Power Brush Block 2302508 Barrier Height Issue

Communique Number

MQUE-5BJNRU

[Revision #CH-429A of [Power Brush Block 2302508 Barrier Height Issue](#) by [Christopher C Hardiman](#)]

Figure 1. Damage Caused by Barrier Height Issue

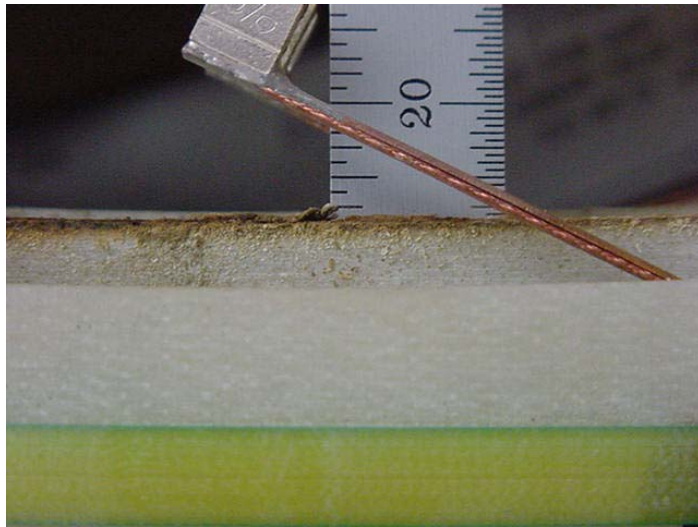
The barriers that are between each of the brushes have been found to be excessively tall in three known cases. They are projecting between .5mm and 1mm higher than specified. This causes the barriers to rub against the slip ring barriers. Please refer to attached images for more details.

Only about 3% of the brushes that have been ordered and installed in the last six months have experienced the problem. After installing a new power brush, manually check clearances by rotating the gantry by hand and observing that the barriers on the brush block clear the slip ring barriers by at least .8 mm. Since radial run out can vary from system to system, measuring the brush blocks may not be conclusive in all cases. IF ANY CONTACT OCCURS DURING MANUAL ROTATION, STOP, REMOVE THE BRUSH BLOCK AND ORDER ANOTHER TO REPLACE IT.
